Access Compliance Report Public Rights-of-Way (Curb Ramps)

Main Street: GARLAND_AVE		Cross Street: RED_HILL_AVE		Location:	N
ADA ID: RPRK220103152548	Ramp Type:Type 1 - Perpendicular Diagonal Initial Pass/Fail: Fail		Overall Compliance: No	Severity Score:	15
Codes/Mitigation Info/Possible Solution			Field Measurements/Component Compliance

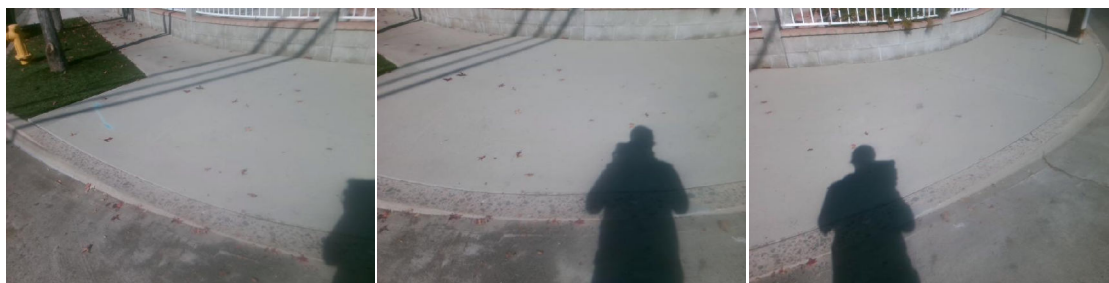
R204.3, R304.2.2, R302.7.2, STD 1115

Remove & Replace Curb Ramp With Two New Directional Ramps or Equivalent. Grind Gutter Lip.
